Product/Process Change Notice (PCN)

PCN #: WL-SIMW_20171215

WL-SIMW 154353xxx all products

PCN Date: September 15th 2017

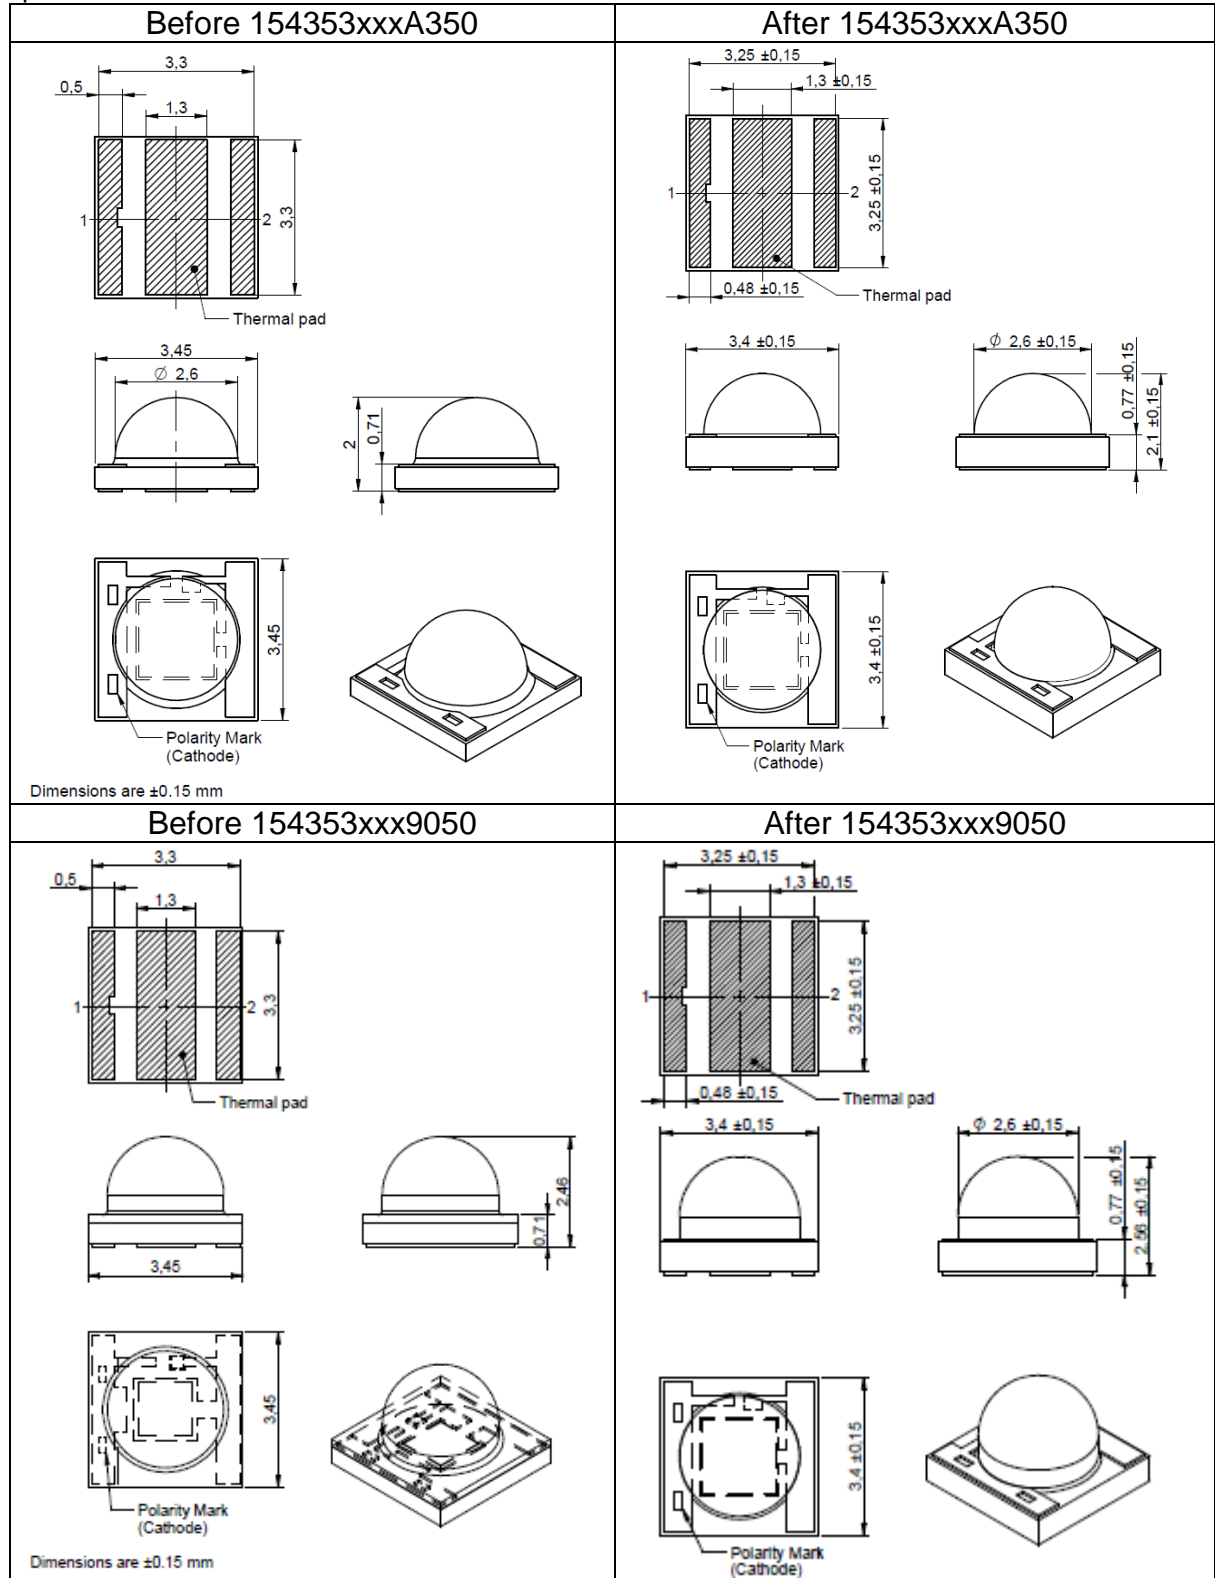
For process improvement purposes, Würth Elektronik will change the dimensions of the substrate for the WL-SIMW line products with 0.05mm

The substrate size will be the only change. The change will not affect the land pattern and soldering specification.
